Access Compliance Report

Public Rights-of-Way

Intersection ID: 50271	Main Street: CLANTON_RD	Cross Street: SOUTH_BV	Location: SW
ADA ID: 1E9AC6EB9983	Ramp Type: Perp	Initial Pass/Fail: Fail	Overall Compliance: No
			Severity Score: 13.75

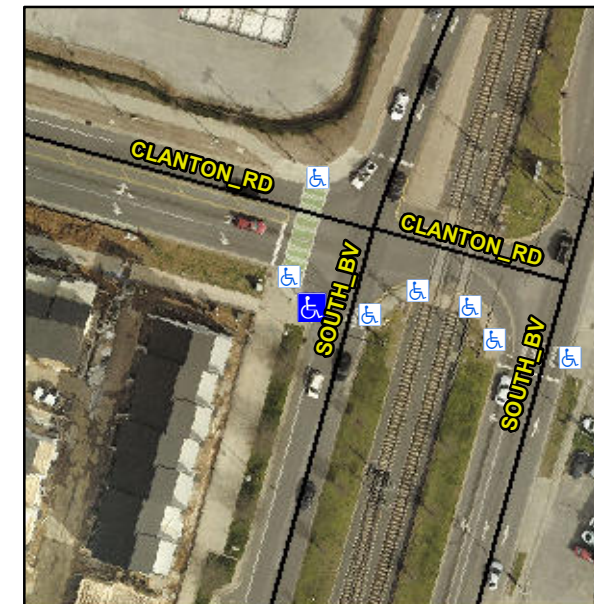
Not Found, R304.2.2

Compliance	Description	Data	Compliance	Description	Data
N/A	Ramp Length (in)	72.0	No	Ramp Slope (%)	9.4
Yes	Ramp Width (in)	48.0	Yes	Ramp XSlope (%)	3.0
N/A	Flare Type LT	N/A	N/A	Flare Type RT	N/A
N/A	Flare Slope LT (%)	N/A	N/A	Flare Slope RT (%)	N/A
N/A	Flare Traversable LT?	N/A	N/A	Flare Traversable RT?	N/A
N/A	Landing Length (in)	N/A	N/A	DWS Provided?	N/A
N/A	Landing Width (in)	N/A	N/A	DWS Contrast?	N/A
N/A	Landing Slope (%)	N/A	N/A	DWS Length (in)	N/A
N/A	Landing X Slope (%)	N/A	N/A	DWS Full Width?	N/A
N/A	Landing Curb? (Y/N)	N/A	N/A	DWS Offset (in)	N/A
N/A	Shared Landing?	N/A			
N/A	Gutter Ponding?	N/A	N/A	Gutter Slope (%)	N/A
N/A	Gutter Lip Ht (in)	N/A	N/A	Gutter X Slope (%)	N/A
N/A	Painted X Walk1?	Yes	N/A	Painted X Walk2?	N/A
	X Walk 1 Direction	To SE		X Walk 2 Direction	N/A
N/A	X Walk 1 Width (in)	125.0	N/A	X Walk 2 Width (in)	N/A
	X Walk 1 Slope (%)	1.8		X Walk 2 Slope (%)	N/A
	X Walk 1 X Slope (%)	3.6		X Walk 2 X Slope (%)	N/A

Remove & Replace Entire Ramp.
